# Access Compliance Report

## Public Rights-of-Way

### (Curb Ramps)

Intersection ID: 14869	Main Street: MEACHAM_ST	Cross Street: OLMSTED_PARK_PL	Location: W
ADA ID: 629F54B3812D	Ramp Type: PerpDiag	Initial Pass/Fail: Fail	Overall Compliance: No
			Severity Score: 21.25

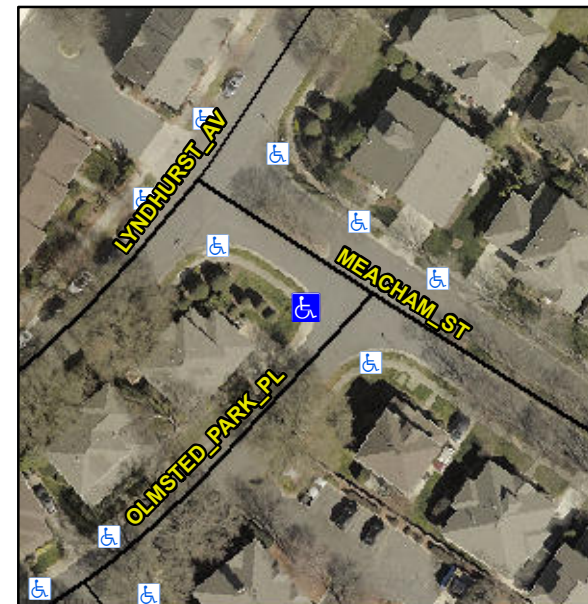
**Not Found, R304.5.1, R304.5.3**

Compliance	Description	Data	Compliance	Description	Data
N/A	Ramp Length (in)	68.0	Yes	Ramp Slope (%)	6.9
No	Ramp Width (in)	39.0	No	Ramp XSlope (%)	5.1
N/A	Flare Type LT	N/A	N/A	Flare Type RT	N/A
N/A	Flare Slope LT (%)	N/A	N/A	Flare Slope RT (%)	N/A
N/A	Flare Traversable LT?	N/A	N/A	Flare Traversable RT?	N/A
N/A	Landing Length (in)	N/A	N/A	DWS Provided?	N/A
N/A	Landing Width (in)	N/A	N/A	DWS Contrast?	N/A
N/A	Landing Slope (%)	N/A	N/A	DWS Length (in)	N/A
N/A	Landing X Slope (%)	N/A	N/A	DWS Full Width?	N/A
N/A	Landing Curb? (Y/N)	N/A	N/A	DWS Offset (in)	N/A
N/A	Shared Landing?	N/A			
N/A	Gutter Ponding?	N/A	N/A	Gutter Slope (%)	N/A
N/A	Gutter Lip Ht (in)	N/A	N/A	Gutter X Slope (%)	N/A
N/A	Painted X Walk1?	No	N/A	Painted X Walk2?	No
	X Walk 1 Direction	To SE		X Walk 2 Direction	To NE
N/A	X Walk 1 Width (in)	N/A	N/A	X Walk 2 Width (in)	N/A
	X Walk 1 Slope (%)	0.1		X Walk 2 Slope (%)	5.9
	X Walk 1 X Slope (%)	3.8		X Walk 2 X Slope (%)	0.3

**Remove & Replace Curb Ramp With Two New Directional Ramps or Equivalent.**
